County of San Diego
Department of Planning & Land Use
BUILDING DIVISION

ACCESSIBILITY CORRECTION LIST Public Accommodations & Commercial Buildings	4B
Ramps

**FIGURE 11B-405.7
RAMP LANDINGS**

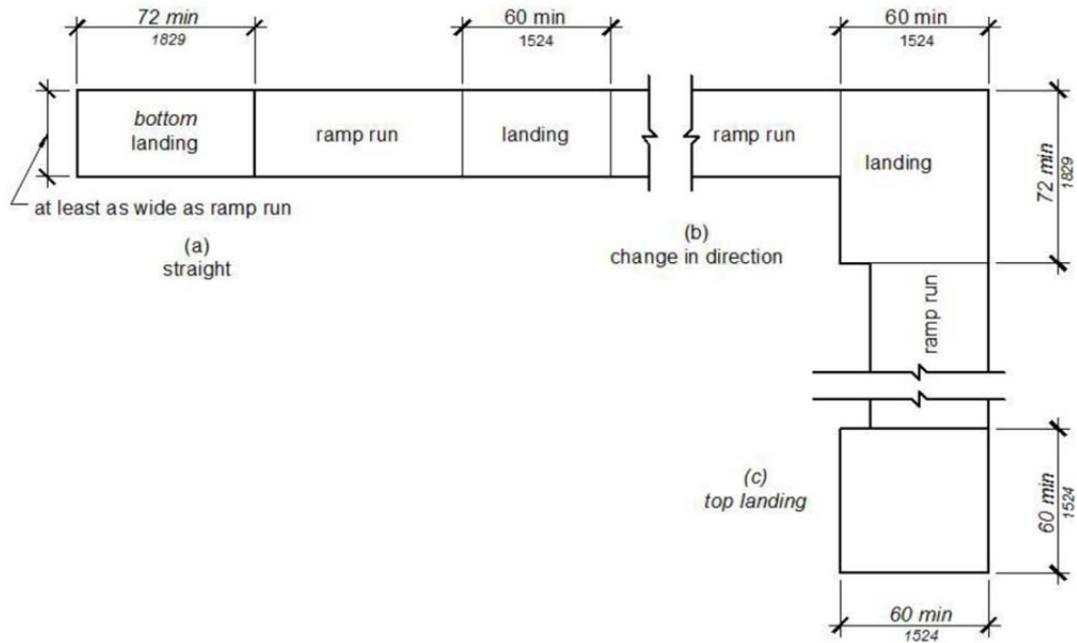
7. Dimension the following level ramp landings per CBC Figure 11B-405.7:
 Top landing:
 - o Minimum 60-inch length
 - o Minimum 60-inch width Bottom landing:
 - o Minimum 72-inch length
 - o Minimum width equivalent to ramp run width Intermediate landing(s) required at changes in direction or where elevations specified per item 5 indicate vertical rise exceeds 30 inches:
 - o Minimum 72-inch length in the direction of downward travel from the upper ramp run at any change of direction
 - o Minimum 60-inch length for other intermediate landings
 - o Minimum 60-inch width at any change of direction
 - o Minimum width equivalent to ramp run width for other intermediate landings
 - o Intermediate landings placed at intervals such that no ramp run exceeds 30-inch vertical rise

**FIGURE 11B-405.9.2
CURB OR BARRIER EDGE PROTECTION**

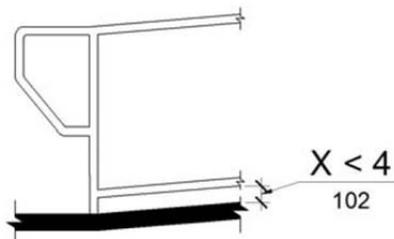
12. At each side of ramp runs and landings not bounded by a wall, detail one of the following:
 - Minimum 4-inch-high continuous guide curb
Exception: Minimum 2-inch-high continuous guide curb acceptable if ramp does not serve as means of egress
 - Minimum 2-inch-high continuous barrier preventing the passage of 4-inch-diameter sphere per CBC Figure 11B-405.9.2
Exception: Edge protection not required on sides of ramp landings serving adjoining ramp run or stairway
Exception: Edge protection not required on sides of ramps not required to have handrails and having flared sides with maximum 10% slope
Exception: Edge protection not required on sides of ramp landings with adjacent vertical drop-off not exceeding 1/2 inch within 10 inches horizontally

**FIGURE 11B-505.10.1
 TOP AND BOTTOM HANDRAIL EXTENSION AT RAMPS**

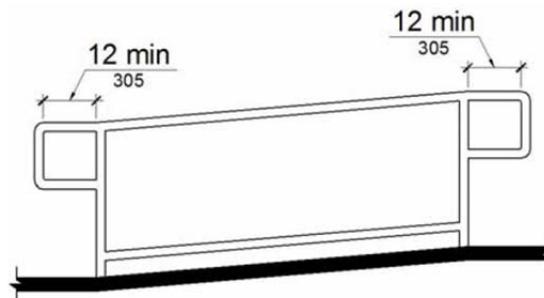
18. Detail extensions for each handrail complying with the following:

- Extending horizontally minimum 12 inches beyond the top and bottom of each ramp run per CBC Figure 11B-505.10.1

- Extending in same direction as ramp run

- Returning to a wall, guard, or landing surface, or otherwise continuous to handrail of adjacent ramp run
- Not protruding into required width of any adjacent route of travel

FIGURE 11B-505.7.2
HANDRAIL NON-CIRCULAR CROSS SECTION

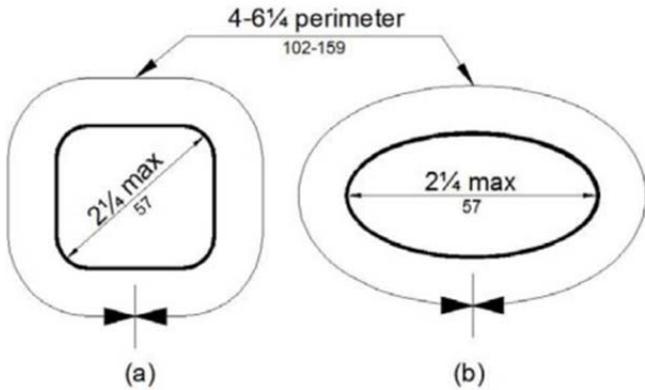
20. Detail handrail gripping surfaces complying with the following:
- If cross section is circular, minimum 1-1/4-inch and maximum 2-inch outside diameter per CBC Figure 11B-505.7.2(a)
 - If cross section is non-circular, minimum 4-inch and maximum 6-1/4-inch perimeter and maximum 2-1/4-inch cross-section dimension per CBC Figure 11B-505.7.2(b)
 - Continuous along length of handrail
 - Unobstructed on tops or sides
 - Not obstructed on bottoms more than 20% of handrail length
 - Any horizontal projections minimum 1-1/2 inches below handrail gripping surface per CBC Figure 11B-505.6
 - Rounded edges
 - No sharp or abrasive elements or adjacent surfaces
 - No handrail rotation within fittings
